Background Materials – December 8, 2025 – Planning Board Meeting

4) 27 Ludlow Road – Detached ADU – Site Plan Review

Move to issue site plan approval upon submittal of a revised site plan eliminating additional driveway curb cut for detached accessory dwelling units on lots 1 and 2 at 27 Ludlow Road, prior to issuance of Building Permit. Building Permit is conditioned upon the Building Commissioner determination that the accessory dwelling units meet the definition of allowable gross floor area.

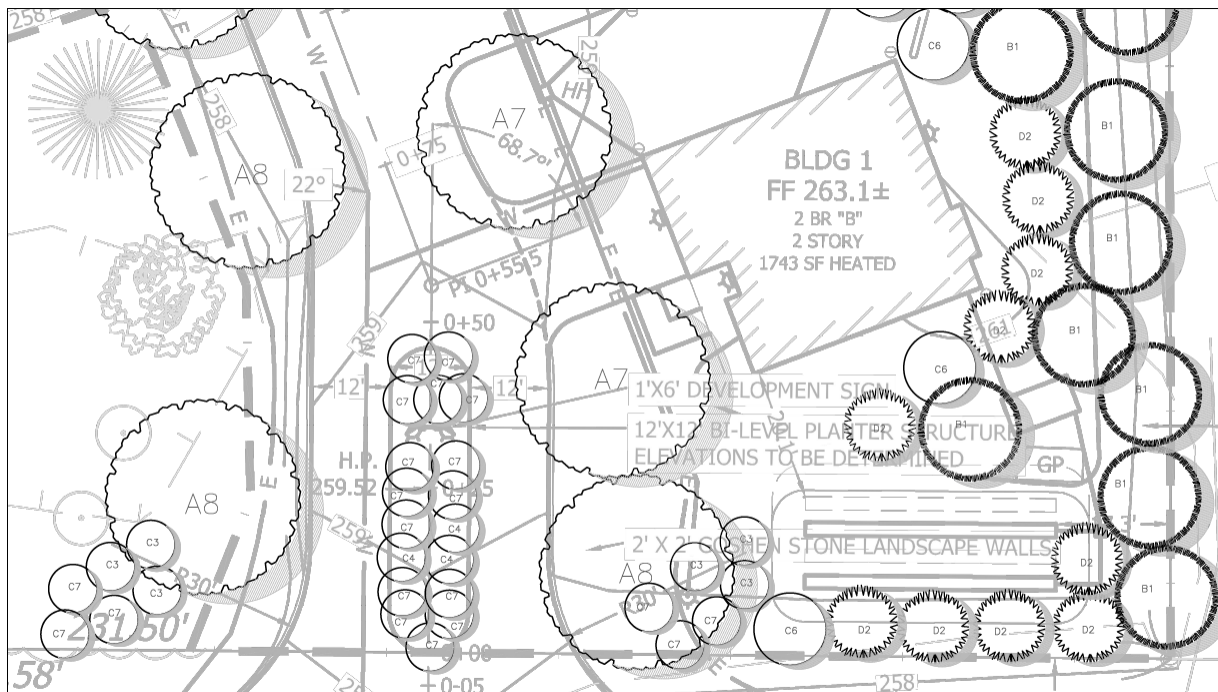
Below is a diagram that Jake [Jacob Nunnemacher, Fire Protection Engineer, Mass State Fire Marshal's Office] sent that shows how the State interprets the Fire Code with regards to access. With this information the following are the options for 27 Ludlow Rd. to comply with the fire code.

1. *No requirements for the ADA on the West to have an access road.*
2. *The ADA on East requires either a 20' access road or fire sprinklers can be installed in this unit as an alternative.*

PLANNING DIRECTOR'S NOTE: The diagram below illustrates the fire code requirement for a minimum of 20' of "open frontage". This frontage does not have to be contiguous. If there is less than 20', a 20' wide fire road is required no matter what the distance from the road is. However, it seemed there was some discretionary options for the Fire District to require a sprinkler in lieu of the full 20' access. The Fire

The revised site plan shows four (4) 20' wide paved driveways attached to the duplexes, plus an additional 20' wide shared driveway for the two detached ADUs. The Board needs to consider whether or not an additional curb cut for the ADUs is allowable or would violate the SPR criteria.

Existing stonewall and median display constructed by developer.

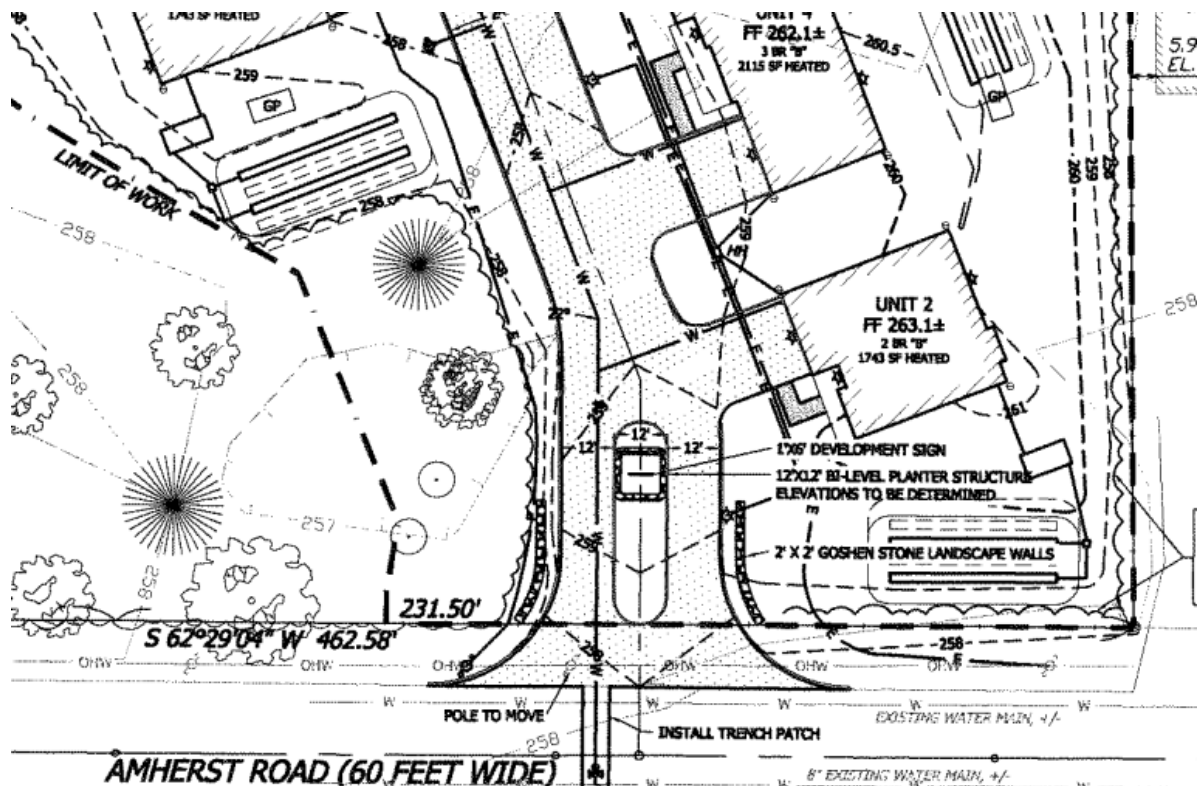
Although the existing stonewall and bilevel median display is on the approved plans, it was installed in the wrong location (too close to the road) and was paved around it thereby eliminating the intended planting area. The developer shall be required to install the plantings required for the median in another appropriate location on the site, to be approved by the Director of Planning and Conservation.

A residential development sign is permitted within this area, however, *the additional "private road no outlet" is not permitted and shall be removed immediately. Other statuary including the metal birds must also be removed.*

In reviewing the median, it seems very problematic for a planting bed to be located there. It seems very likely that plants would be driven over, plowed over, and destroyed within a year. I am recommending that the Board approve the median in the current location, and require enhanced planting on the south side of Skinner Way along the ROW setback. Plantings are to be of the same species and quantities as indicated for the median planting. The only ornamentation allowed on the median is a development name sign. All statuary and other signs are to be removed.
